SERVICE BULLETIN

SB No. AX2008 ISSUE No. 1

TITLE AX2000 BATTEN POCKET CLOSURES and AX2000 JOYSTICK LIMIT CABLE

APPLICABILITY Cyclone AX2000 first three production aircraft, reg. G-MZFA, G-MZGC and G-MZER.

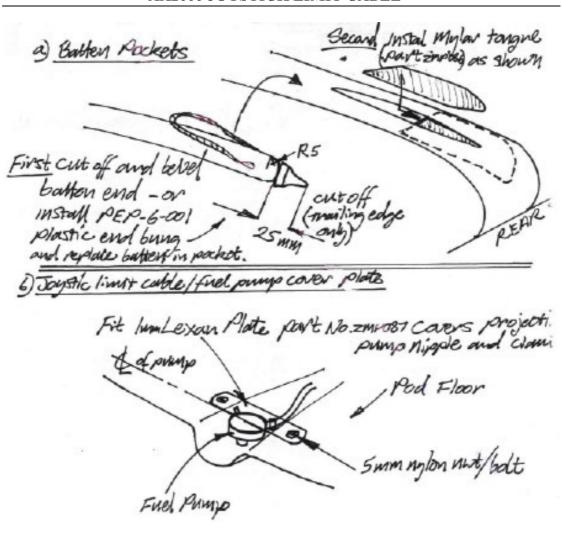
It has been found that some of the top surface wing battens can move out of the batten pockets in the sail. If a batten moves out far enough, it is possible for it to foul the ailerons. This must be prevented on theses three aeroplanes by changing the design of the batten end caps and by inserting a mylar sliding tongue into the batten pocket closure according to minor mod. AX104.

It is just conceivable that the joystick limit cable could loop around the fuel pump and restrict elevator travel. To physically prevent this possibility, a lexan guard plate is introduced which covers the fuel pump on the above three aeroplanes only.

Remove the plastic batten ends from the trailing edge of each batten. Replace with PEP-6-001 3/4" plastic end bungs. Alternatively, saw off 20mm of the pointed end of the batten end and bevel the cut edges with a file.

Replace the battens and insert a mylar tongue into each batten pocket slit as shown in the attched sketch. Slide the tongue rearwards so as to close off the end of the pocket.

Fit the lexan fuel pump cover plate to the pod as indicated in the attached sketch with two 5mm plastic nuts and bolts.
